## **ADDENDUM NO. 3**

### Project Name: INDIAN RIVER COUNTY MAIN LIBRARY ROOF REPLACEMENT (IRC-1838)

Bid Number: **2020029**

<image/> <section-header><text><text><text></text></text></text></section-header>
IRC-1838 INDIAN RIVER COUNTY MAIN LIBRARY ROOF REPLACEMENT 1600 21st STREET VERO BEACH, FL 32960 REI PROJECT# 019TPA-027
REVISION #   REVISION DATE     1   05-15-2020     2   3     3
ROOF DETAILS

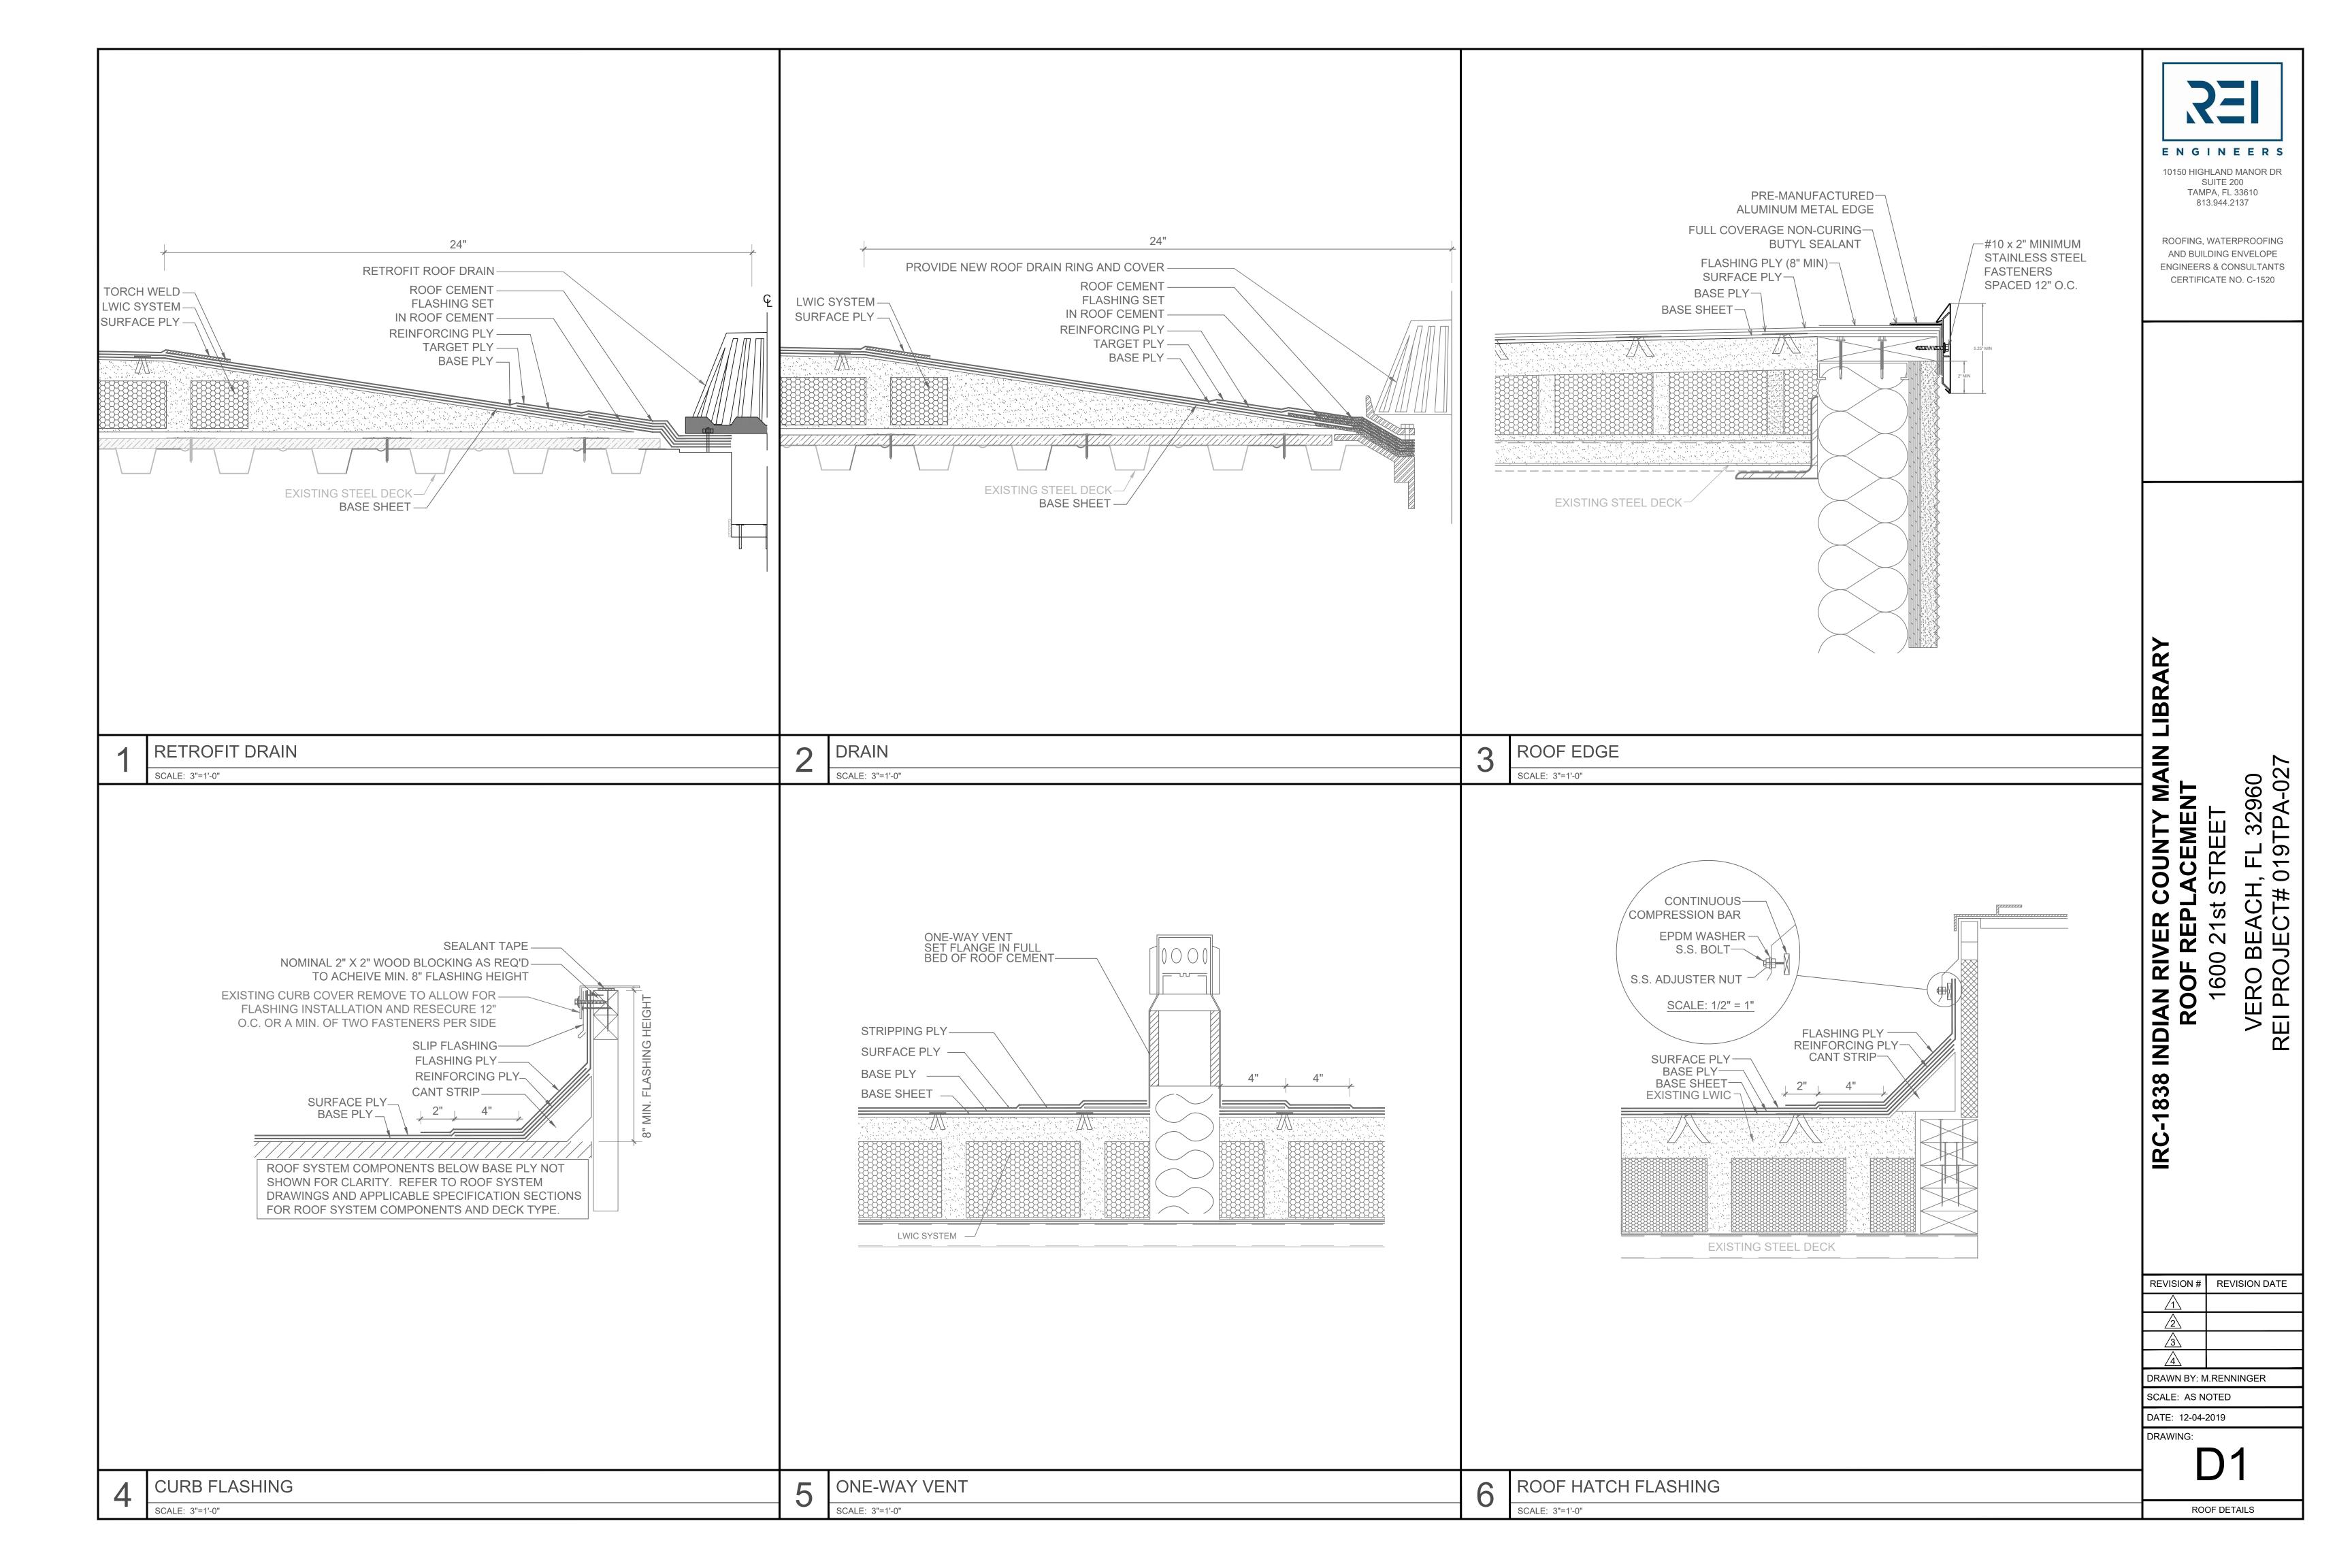
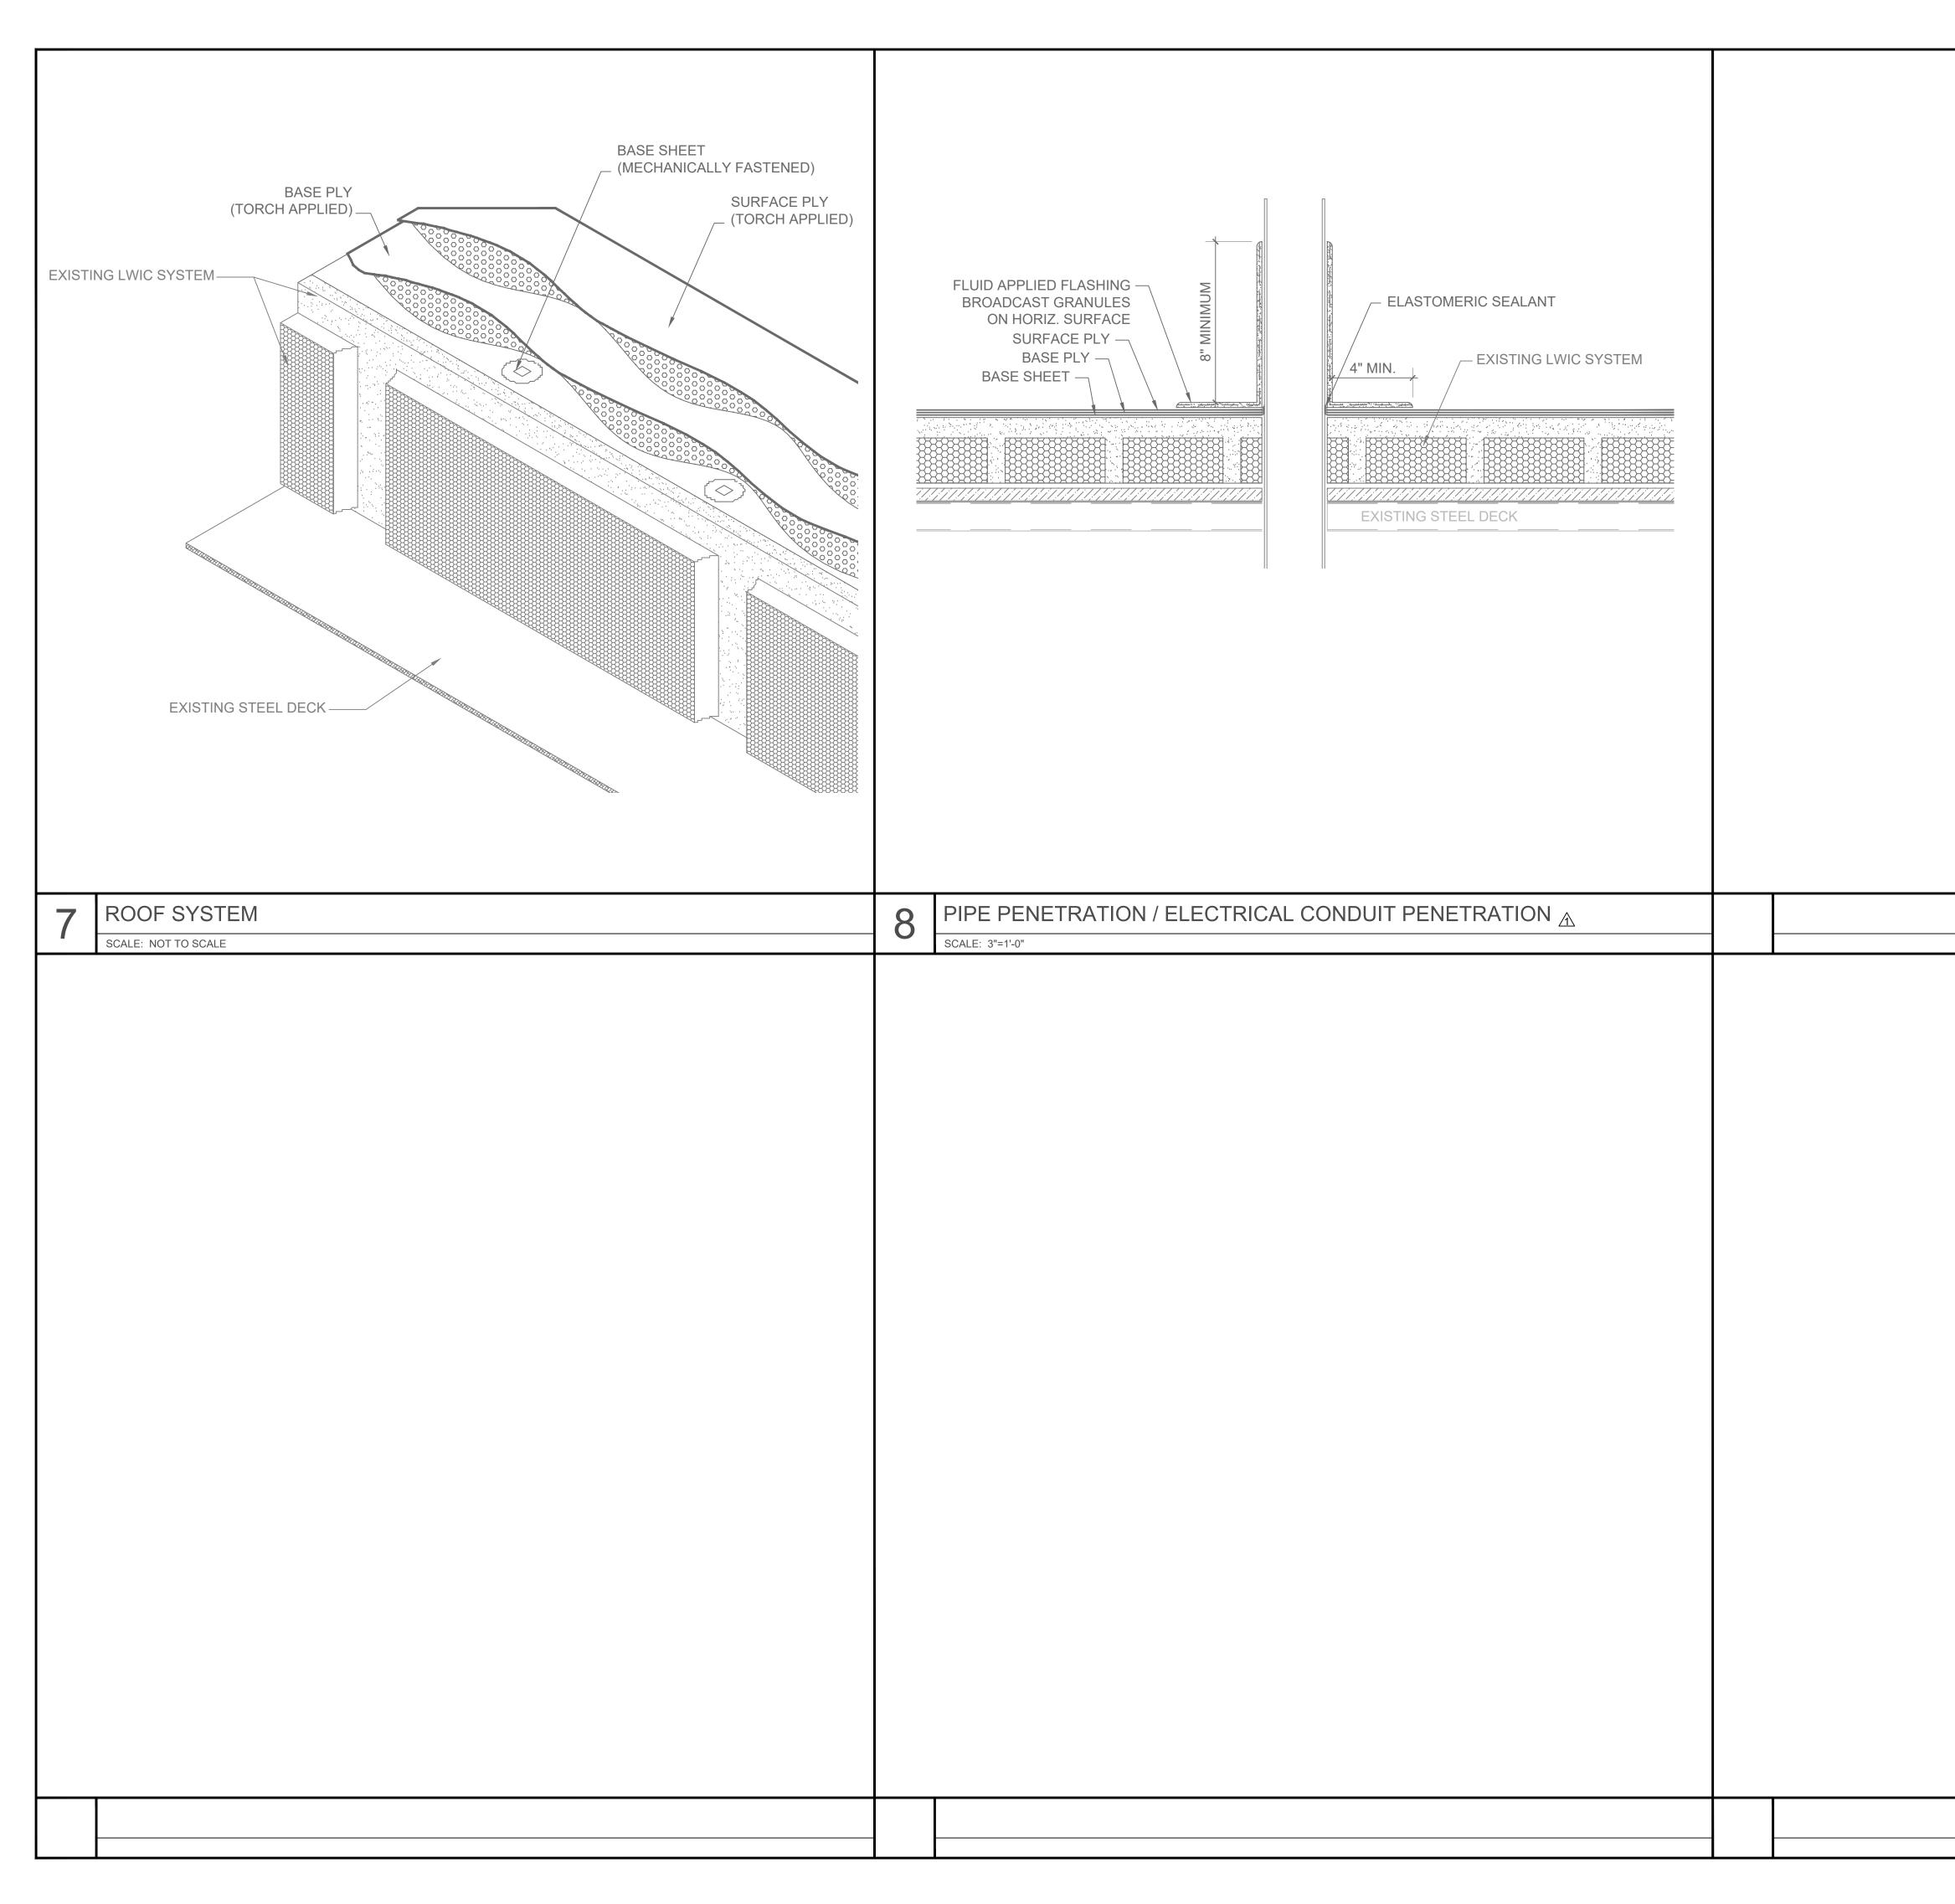
- Replace Specification Section "Contract Drawing D2" with attached "Contract Drawing D2 (Revision No. 1)". Contract drawing has been updated to clarify electrical conduit flashing requirements.
